FINAL
Environmental Impact Statement
Lone Tree Mine
Expansion Project

**FINAL
ENVIRONMENTAL IMPACT STATEMENT
SANTA FE PACIFIC GOLD CORPORATION
LONE TREE MINE EXPANSION PROJECT**

The Final Environmental Impact Statement (FEIS) provides responses to comments received by BLM during the public comment period on the Draft Environmental Impact Statement (DEIS). The DEIS analyzed potential impacts associated with expansion of the Lone Tree Mine located in northern Nevada, analysis of alternatives to the Proposed Action, and identified mitigation measures to be implemented to eliminate or reduce described impacts. The Proposed Action includes: (1) expansion of the existing Lone Tree Mine open pit, (2) continuation of the mine dewatering and discharge system, (3) expansion of the tailings impoundment facility, (4) expansion of the overburden disposal facility, and (5) reclamation of disturbed areas. Components of both the Proposed Action and No Action Alternative are evaluated in detail in this document. Other alternatives were considered, evaluated, and eliminated from further detailed analysis. The Agency Preferred Alternative includes the Proposed Action with additional mitigation meas

FIGURE 3-13

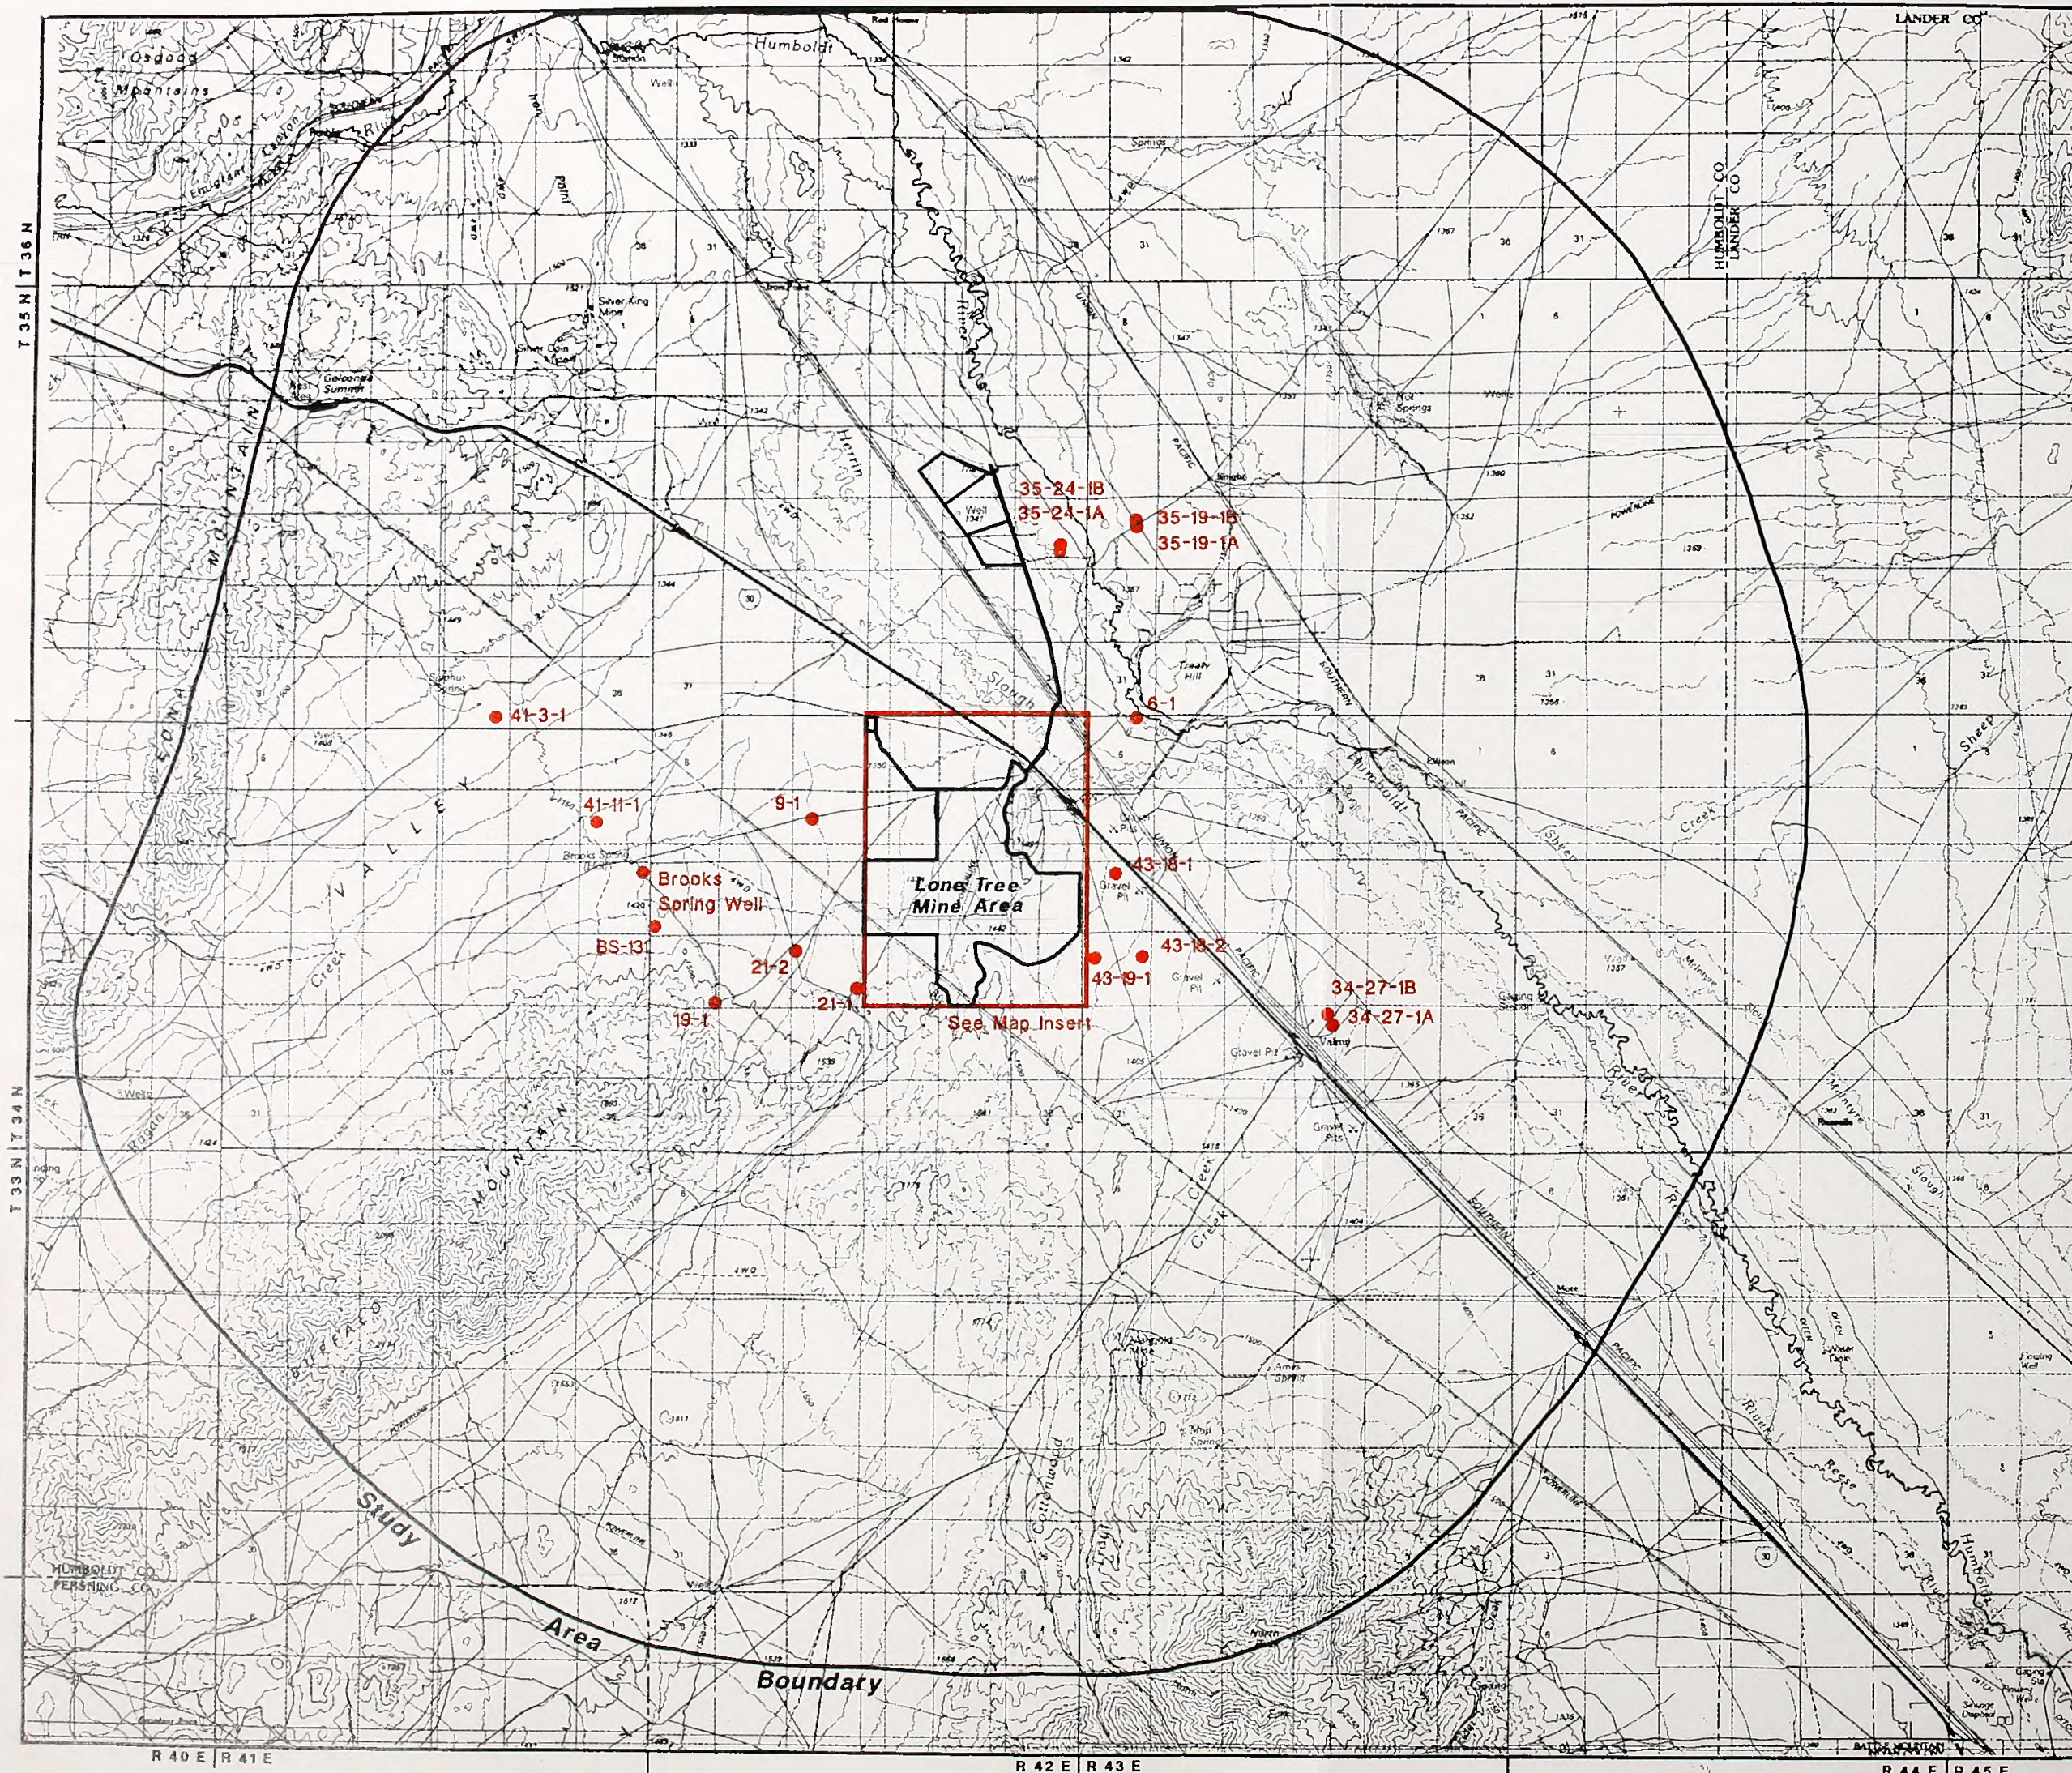
The wells described on Table 3-19 cannot be found on any map provided in the DEIS, and Table 3-21 has inadequate well location descriptions. The wells do not correspond with Figure 3-13. It is, therefore, not possible to draw relational conclusions between mine activities and well parameters. The FEIS should provide a map or a correlation.

Figure 3-13 (Groundwater Monitoring Wells) in the DEIS (page 3-51) is modified to include additional wells (see Revised Figures section at the end of this chapter).

From Table 3-19, wells M/O 11-2, OW-9A, and M/O 35-19-1B are shown on Figure 3-13; however, the M/O prefix has been removed to allow more room on the figure for labels. Wells WW-2, WW-4, WW-5, WW-10, and WW-12 are mine dewatering wells located immediately around the mine pit. The majority of wells listed in Table 3-21 are shown on Figure 3-13. The wells that were omitted from the figure in the DEIS have been added to revised Figure 3-13 in this FEIS (see Errata section in Chapter 3).
